ECE/TRANS/WP.29/GRSP/2009/22
23 September 2009

REGULATION No. 11
(Door latches and hinges)

Proposal for the 04 series of amendments to Regulation No. 11

Submitted by the expert from the European Commission */

Annex 1, amend to read:

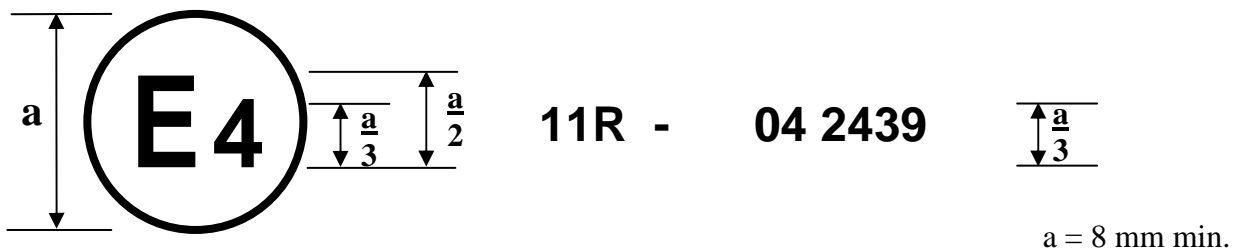
"...with regard to **the doors** pursuant to Regulation..."

Figure 7-1

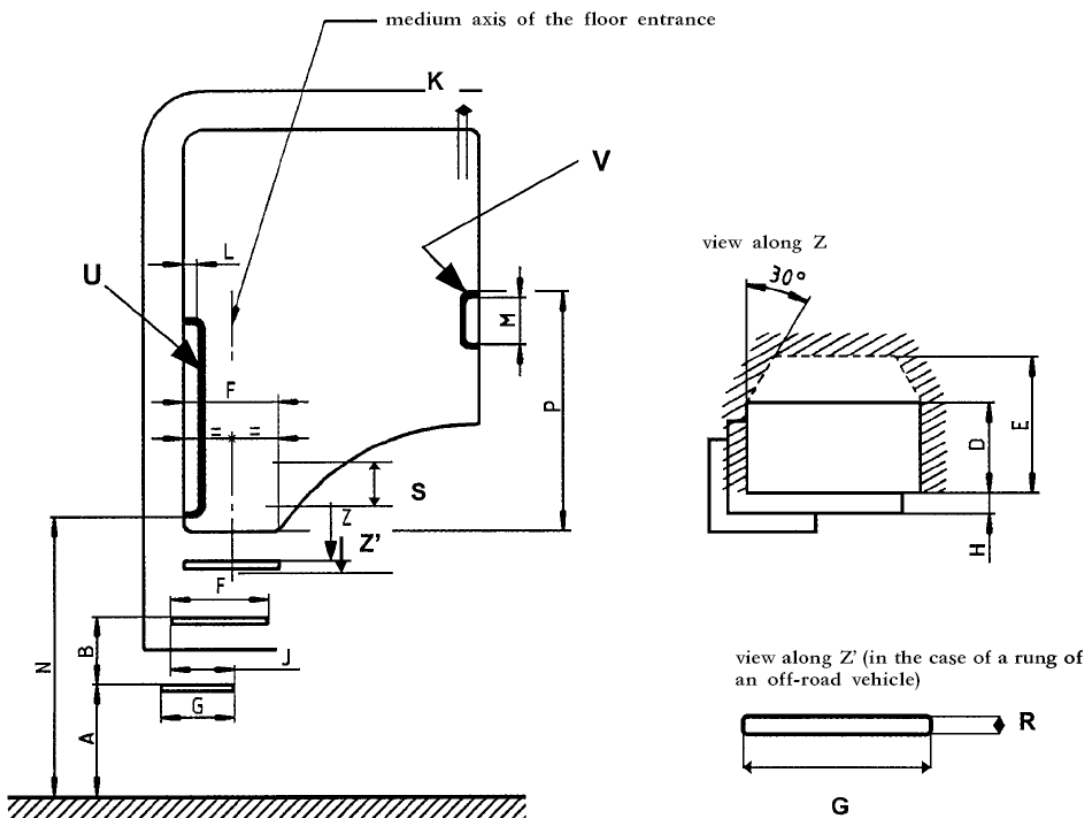
- 1. Access steps to the driver's compartment (see figure 7-1)**
 - 1.1. The distance (A) from the ground to the upper surface of the lowest step, measured with the vehicle in running order on a horizontal and flat surface, shall not be more than 600 mm [400 mm].**

- 1.2. The distance (B) between the upper surfaces of the steps shall be not more than 400 mm [350 mm]. The vertical distance between two subsequent steps shall not vary by more than 50 mm. The last requirement shall not apply to the distance between the uppermost step and the cab floor.**

- 1.3. In addition, the following minimum geometrical specifications shall be fulfilled:**
 - (a) step depth (D): 80 mm**
 - (b) step clearance (E) (include step depth): 150 mm**

- (c) step width (F): 300 mm [230 mm]**
 - (d) width of the lowest step (G): 200 mm [230 mm]**
 - (e) step height (S): 120 mm**
 - (f) transversal offset between steps (H): 0 mm**

- (g) longitudinal overlap (J) between two subsequent steps in the same flight, or between the uppermost step and the cab floor: 200 mm.**
 - 1.3.1. However, for off-road vehicles (see paragraph 1.1.1.) the value (F) may be reduced to 200 mm.**

2. Access to handholds to the driver's compartment (see figure 7-1)
 - 2.1. One or more suitable handrails and handholds or other equivalent holding devices shall be provided for the access to the driver's compartment.

- 2.1.5. The steering wheel may be considered as a handhold.
 - 2.2. The height (N) of the lower edge of at least one handrail or handhold or equivalent holding device, measured from the ground with the vehicle in running order on a horizontal and flat surface, shall not be more than 1 850 mm [1 600 mm].

- 2.2.2. If the floor of the driver's compartment has a height from the ground greater than "N", this height shall be assumed as "N".
- 2.2.3. In addition, the minimum distance (P) of the upper edge of the handrail(s) or handholds or equivalent holding devices from the floor of the driver's compartment shall be:
- (a) handrail(s) or handholds or equivalent holding devices (U) 650 mm,
 - (b) handrail(s) or handholds or equivalent holding devices (V) 550 mm.
- 2.3. The following geometrical specifications shall be fulfilled:
- (a) gripping dimension (K): 16 mm minimum 38 mm maximum [25 mm minimum 30 mm maximum],
 - (b) length (M): 150 mm minimum,
 - (c) clearance to vehicle components (L): 40 mm [70 mm] minimum with open door.
